Addenda No. 1

SUBJECT: US101 & OR38: Reedsport to Winchester Bay Paving
Oregon Coast Highway
Douglas County
Grading, Paving & Sidewalks Project
(Bids to be opened and read February 26, 2009)

The following changes are made to the Project Bid Booklet:

SHEET NO. 9

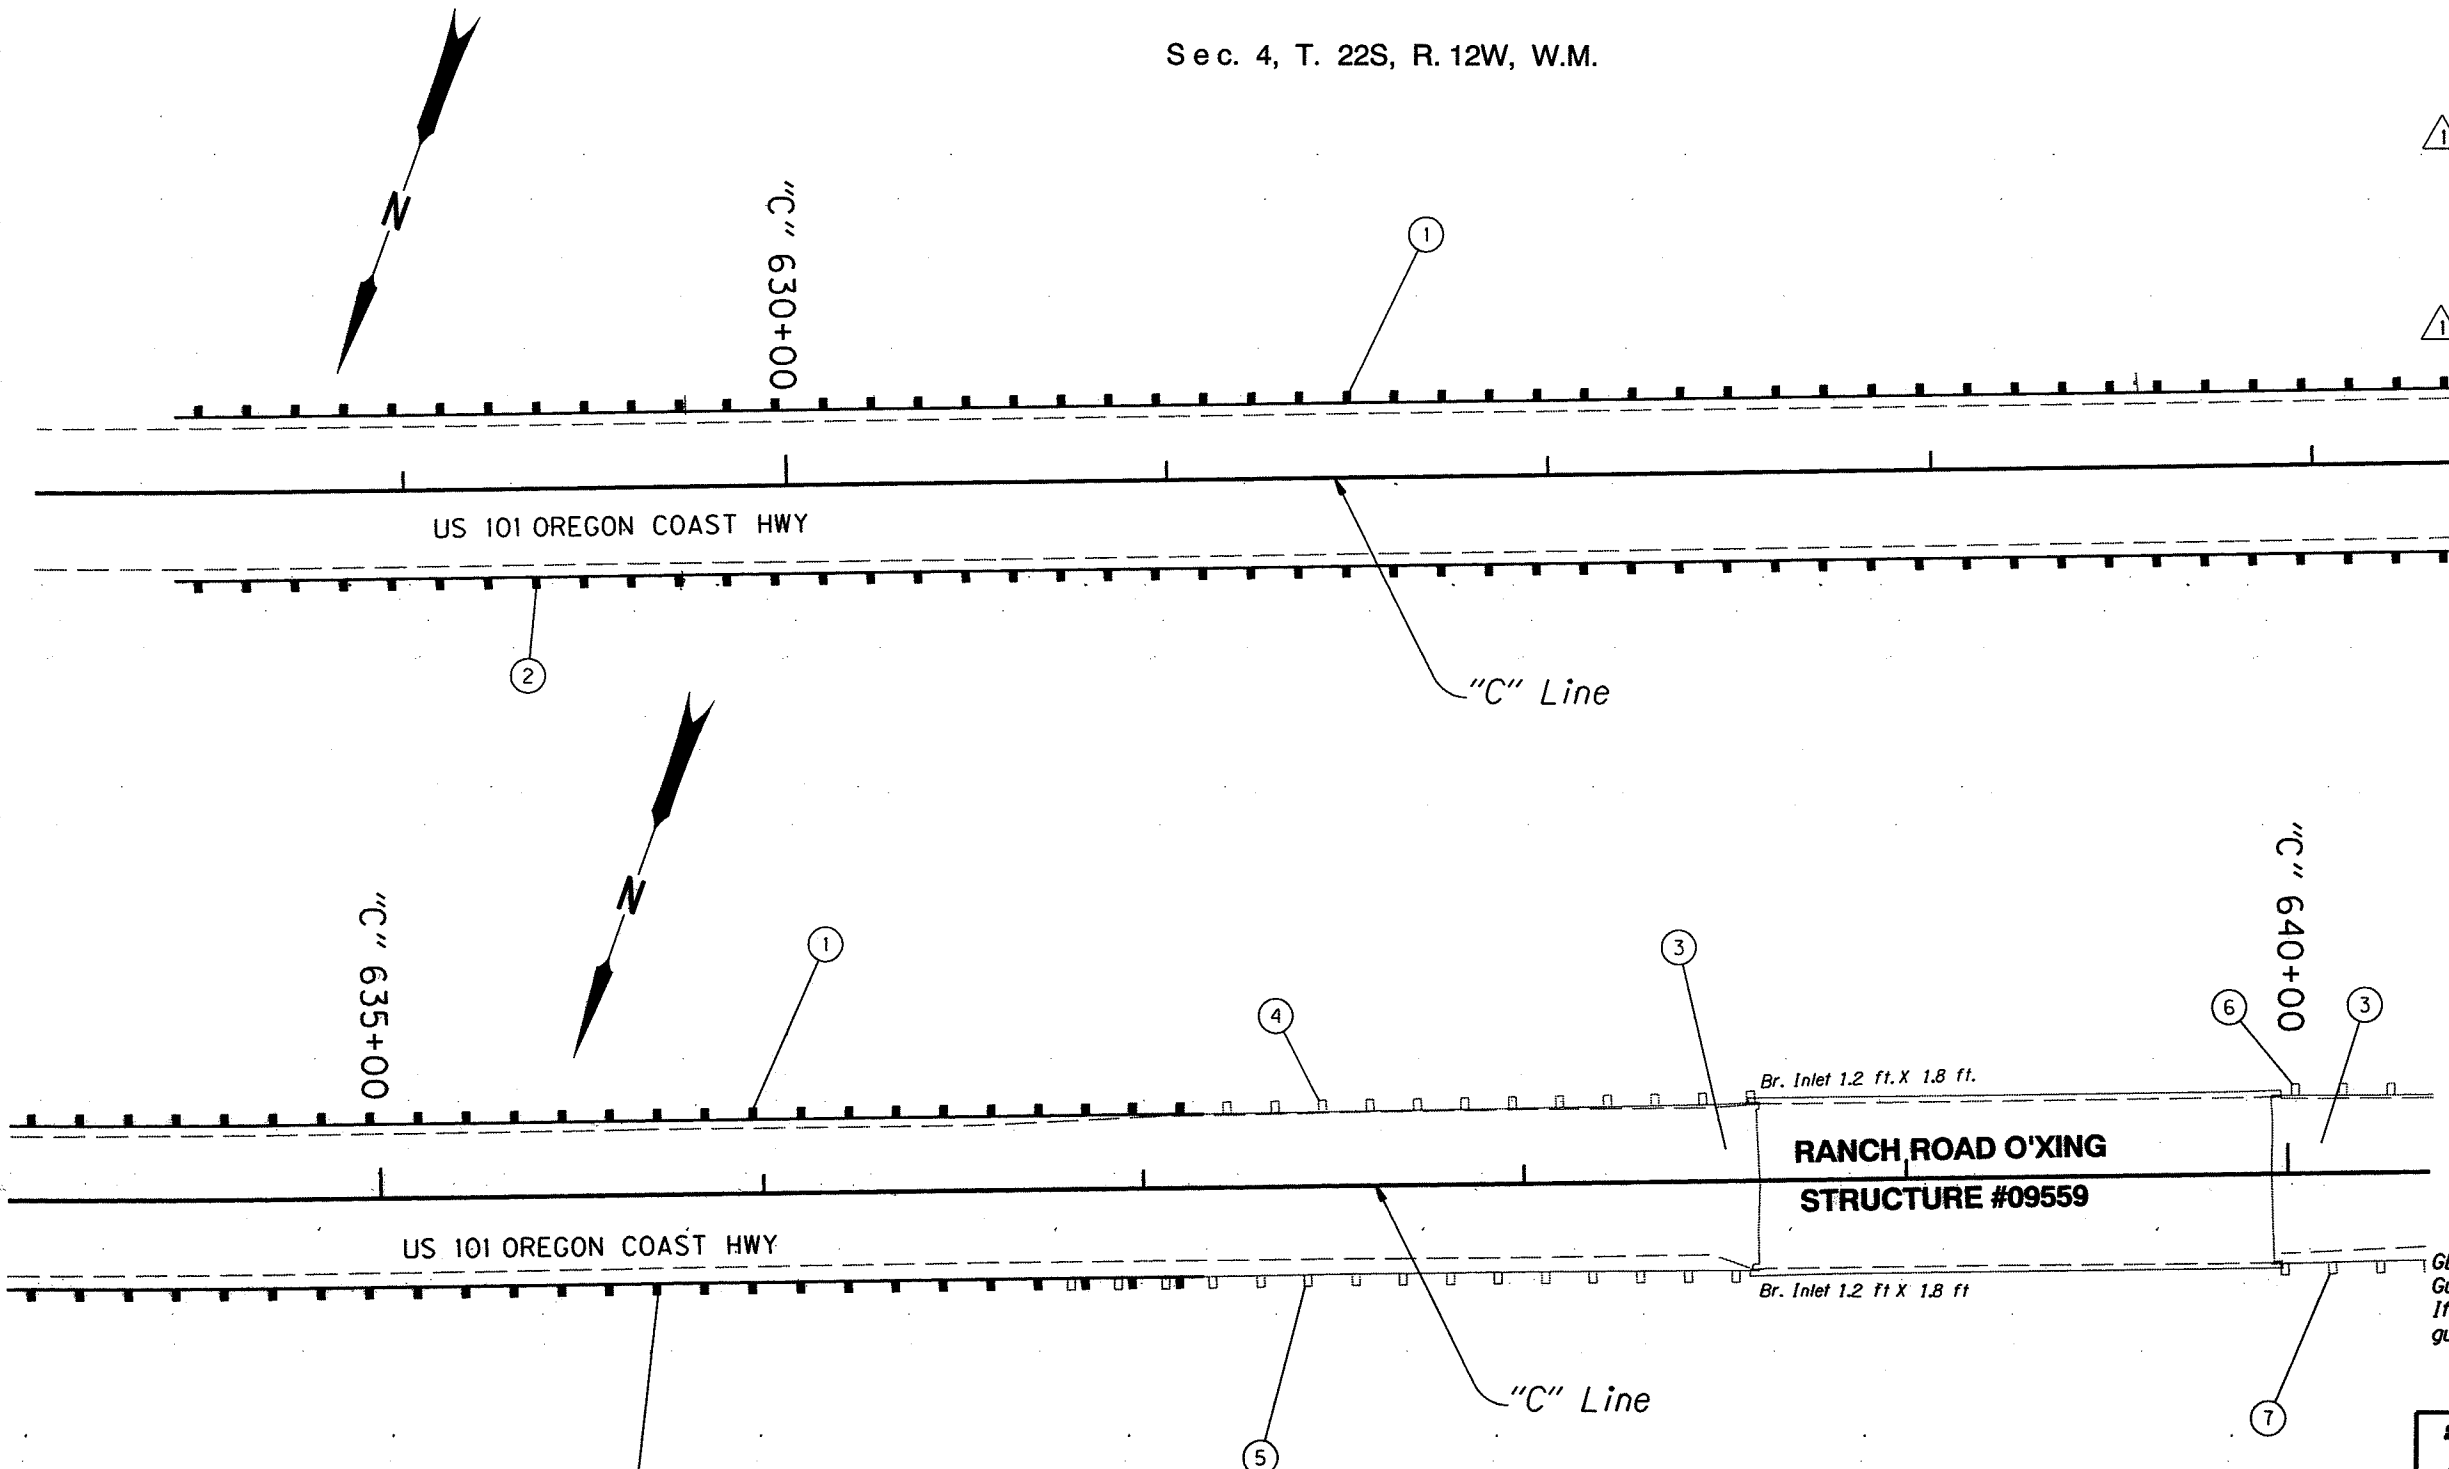
- ⑦ Sta. "C" 581+62.42, 33.17' Rt.
Const. Type "G-1" inlet
Inst. 12" sew. pipe - 22'
5' depth
Connect pipe to extg. inlet
(-0.5% min. slope on pipe)
- ⑧ Const. monolithic curb & sidewalk - 494.0 sq. ft.
E = 7"
Extra for asphalt slope paving - 121.1 sq. ft.
(For details, see sht. 2B-2)

- ⑨ Remove extg. curb & sidewalk - 30'
Const. monolithic curb & sidewalk - 130.7 sq. ft.
E = 7"
(For details, see sht. 2B-2)
- ⑩ Remove extg. curb & sidewalk - 30'
Const. monolithic curb & sidewalk - 244.2 sq. ft.
E = 7"
(For details, see sht. 2B-2)

- ⑪ Const. monolithic curb & sidewalk - 92.4 sq. ft.
E = 7"
Extra for asphalt slope paving - 20.7 sq. ft.

Rev. No.	Description	Date	Engineer
①	Note addition	2-19-09	JB

SHEET NO. 16

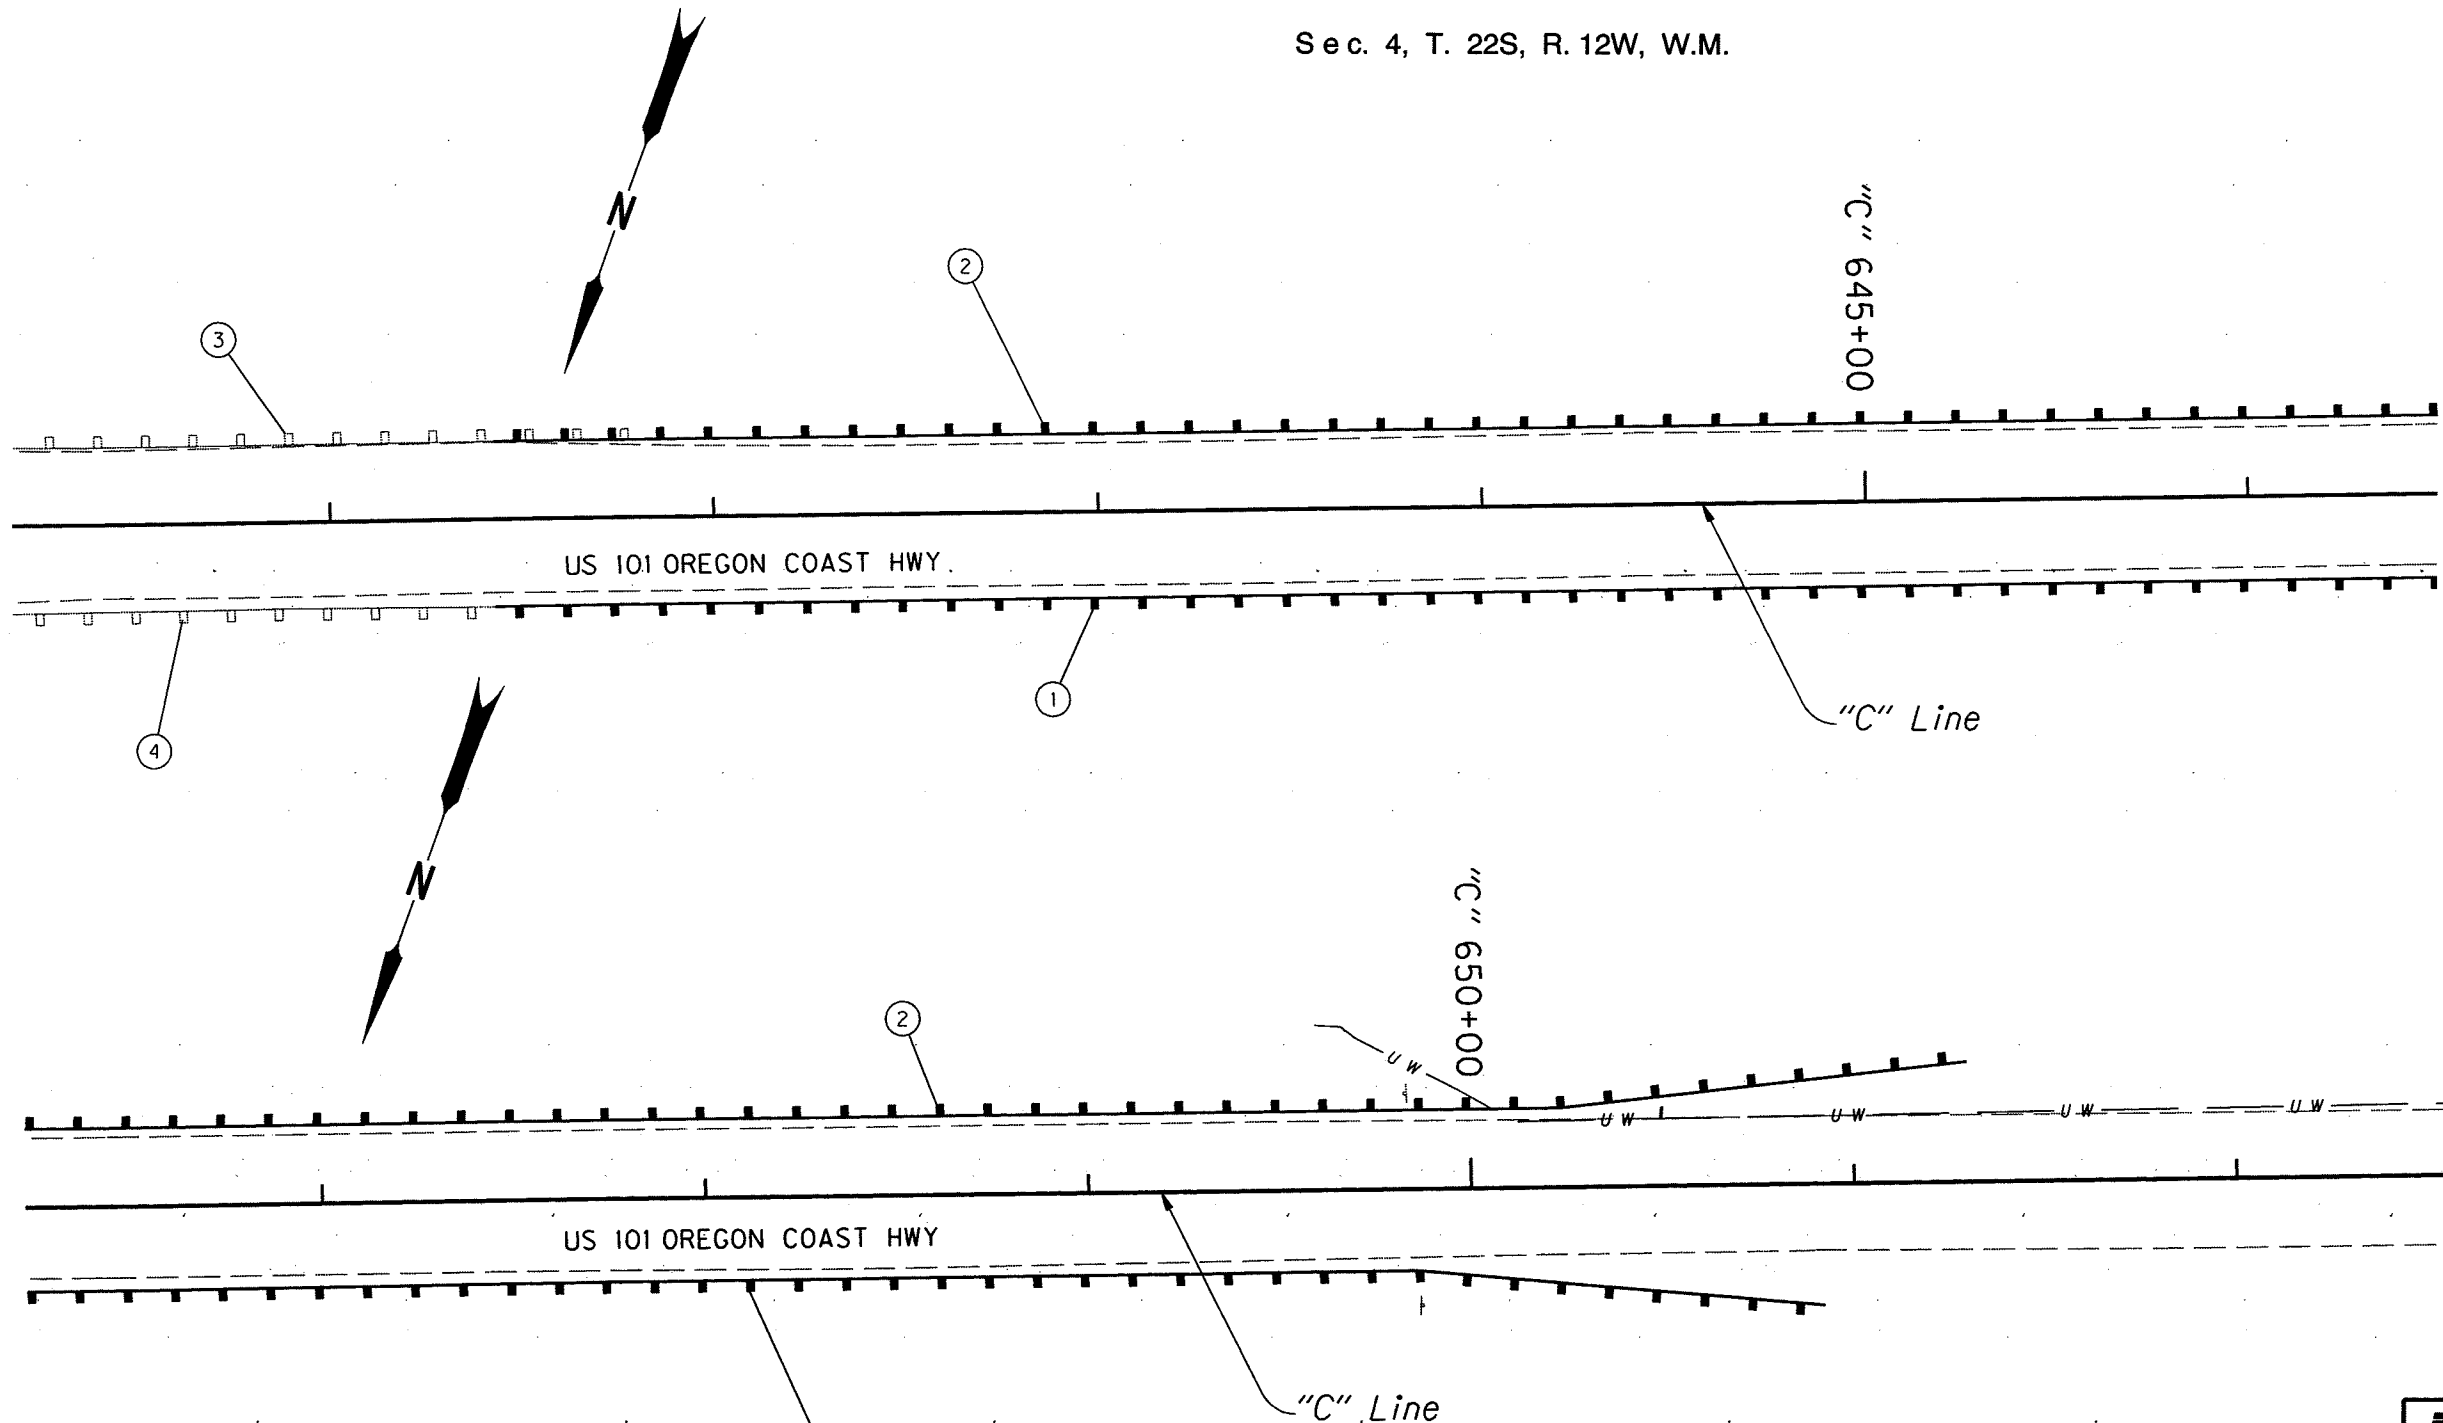
- ① Sta. "C" 628+41 to Sta. "C" 637+16, Lt.
Remove extg. guardrail terminal - 37.5'
Const. guardrail - 837.5' (Type 2A)
W=4', E=2'
Const. guardrail terminal, non-flared
Connect to extg. guardrail
- ② Sta. "C" 628+41 to Sta. "C" 637+16, Rt.
Remove extg. guardrail terminal - 37.5'
Const. guardrail - 837.5' (Type 2A)
W=4', E=2'
Const. guardrail terminal, non-flared
Connect to extg. guardrail
- ③ Approach reconstruction - 2
(For details, see sht. 2B)
- ④ Adjust guardrail - 50'
(For details see sht. 2B-2)
- ⑤ Adjust guardrail - 50'
(For details see sht. 2B-2)
- ⑥ Adjust guardrail - 50'
(For details see sht. 2B-2)
- ⑦ Adjust guardrail - 50'
(For details see sht. 2B-2)

GENERAL NOTE:
Guardrail design is based on a terminal length of 37.5'.
If a longer terminal is used, reduce the length of Type 2A
guardrail accordingly.

Rev. No.	Description	Date	Engineer
①	Note addition	2-19-09	JB
